Access Compliance Report

Public Rights-of-Way

Intersection ID: 7969	Main Street: BROOKSHIRE BV	Cross Street: N_HOSKINS_RD	Location: NW
ADA ID: 3EF5BCB4F7F1	Ramp Type: Para	Initial Pass/Fail: Fail	Overall Compliance: No
			Severity Score: 26.25

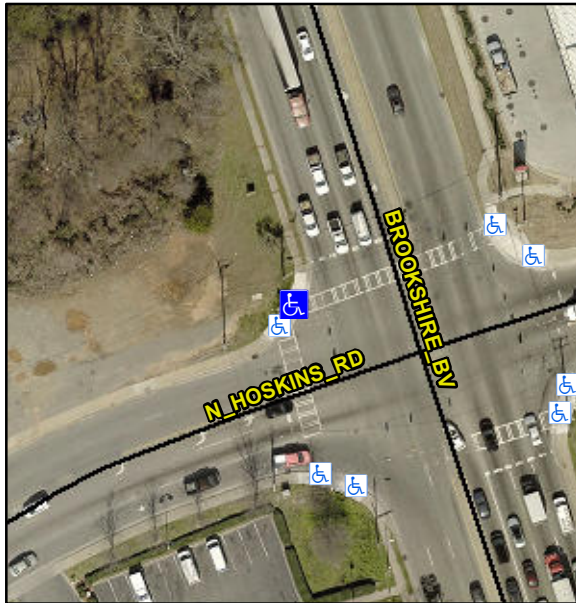
LT RP < 5%

R304.3.2, R304.5.3

Remove & Replace Entire Ramp.
